**RAI Volume 3, Chapter 2.2.1.4.1, First Set, Number 2:**

**RAI Volume 3, Chapter 2.2.1.4.1, First Set, Number 3:**

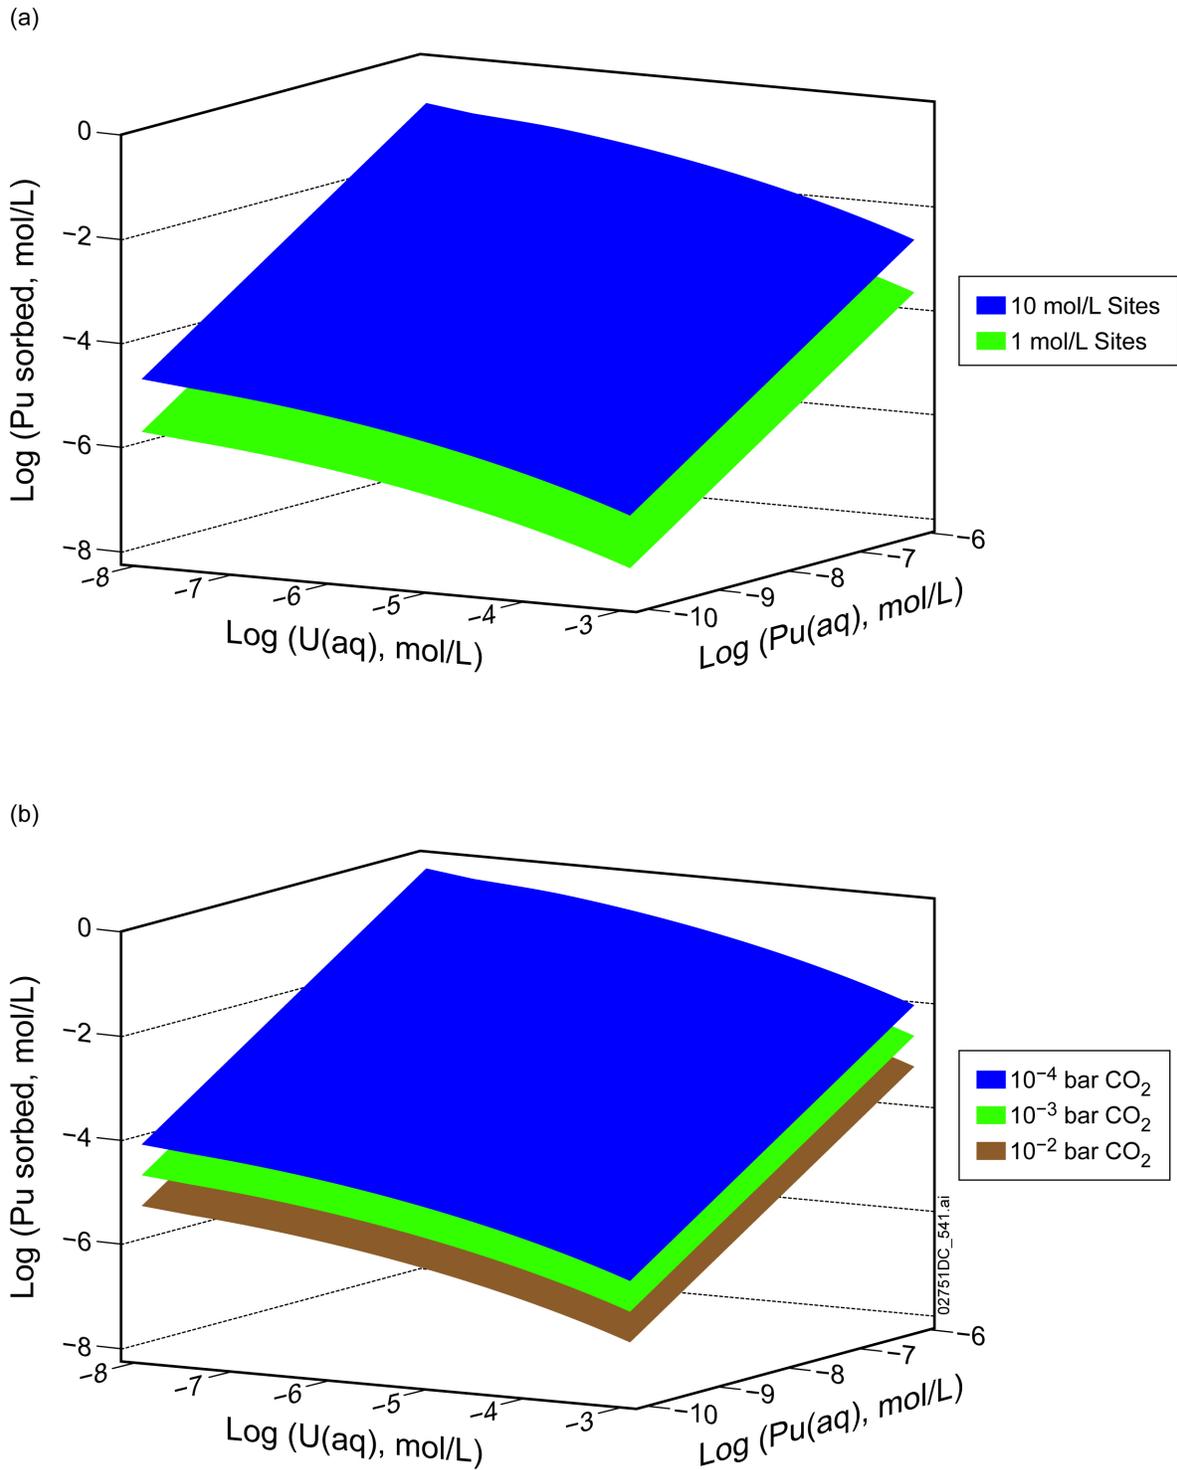
SAR Section 2.1.2.2 states that, “Sorption of dissolved radionuclides on corrosion products in the waste package... is a beneficial process of the EBS when the waste packages are breached.” Discuss the performance aspects of stationary corrosion products in terms of their impact on the timing and magnitude of plutonium release from the corrosion product domain. The discussion should include:

- The factors that control plutonium release from the stationary corrosion products and corrosion product domain. Controlling factors may include precipitation/dissolution reactions, solubility limits, sorption to colloids, pH, ionic strength, water flux, and mass of corrosion products
- A quantitative description of the timing and magnitude that these factors impact radionuclide release from the corrosion product and corrosion product domain
- Intermediate TSPA results corroborating the discussion of these interactions
- Release statistics/masses/concentrations for sorption to the corrosion products, release from the corrosion products and release from the corrosion product domain on a per waste package basis
- Consideration of the various scenarios (e.g. early failure, seismic, igneous, human intrusion)

Response surfaces defined by the equilibrium plutonium sorption equation are displayed in Figure 1.1.1-1 for the general ranges of values of the independent parameters in the TSPA realizations presented in Section 1.2. Figure 1.1.1-1(a) shows a strong dependence on the aqueous plutonium and surface site concentrations. It also shows, along with Figure 1.1.1-1(b), a limited but increasing inverse dependence on the aqueous uranium concentration as the aqueous uranium concentration increases. The increasing dependence with increasing aqueous uranium concentration is due to the second order term in the sorption equation. In addition,

Figure 1.1.1-1(b) shows the relatively small dependence on the CO<sub>2</sub> partial pressure. These response surfaces indicate that the sorbed plutonium concentrations exceed the aqueous plutonium concentrations by approximately three to five orders of magnitude for the ranges plotted.

Figure 1. Probability Distribution and Statistics for Erupted Tephra Volume

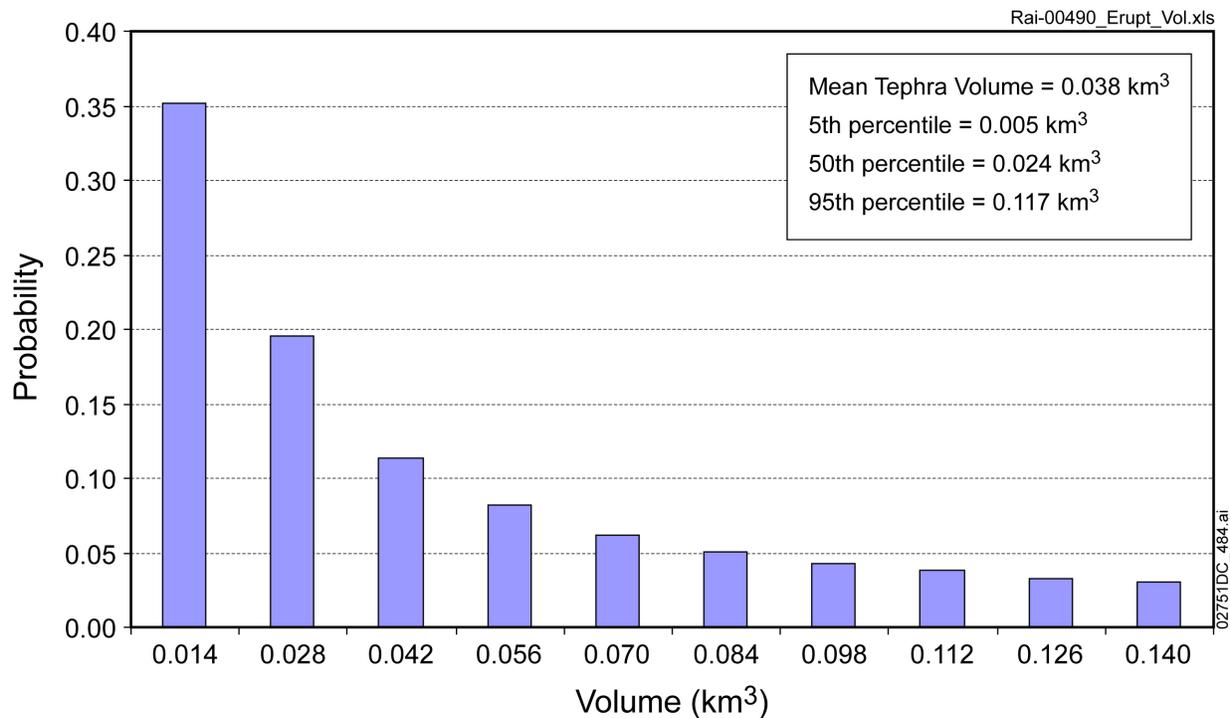
Clarify the technical basis for the values used to represent the tephra volume for the volcanic eruption modeling case.

Basis: The SAR provides an estimated range for the total volume of past eruptive events of 0.004 to 0.12 cubic kilometers (Table 2.3.11-2). The SAR also states that the tephra volume is expected to be significantly less than the total volume (i.e., tephra volume estimated for the Lathrop Wells is 0.07 cubic kilometers versus 0.12 cubic kilometers for the total volume – page 2.3.11-50). Implementation of the eruptive modeling case in the TSPA has minimum and maximum values of 0.004 and 0.14 cubic kilometers for use in developing inputs for the ASHPLUME code. These minimum and maximum values reflect the total volume not the tephra volume. Only the latter is significant to the dispersal of radionuclides entrained in tephra. This information is needed to determine compliance with 10 CFR 63.114.

A distribution of tephra volumes equivalent to that used in the TSPA volcanic eruption modeling case was developed for this response using the equations that constrain eruptive mass flux (SNL 2007b, Equations 8-1a and 8-1b) and the probability distributions used for eruptive power, duration, and tephra density. The resulting tephra volume distribution and associated statistics are shown in Figure 1. Because eruption duration and power are sampled using a log-uniform distribution, the erupted tephra volume shown in Figure 1 follows a similar distribution. As shown in the figure, values in the upper end of the range of tephra volumes have a relatively low probability of occurring. The figure also shows that the mean value of tephra volume is 0.038 km<sup>3</sup> and half of the sampled values are less than 0.024 km<sup>3</sup>. These values reasonably represent the uncertainty in tephra volume and are consistent with the values of total volume shown in SAR Table 2.3.11-2.
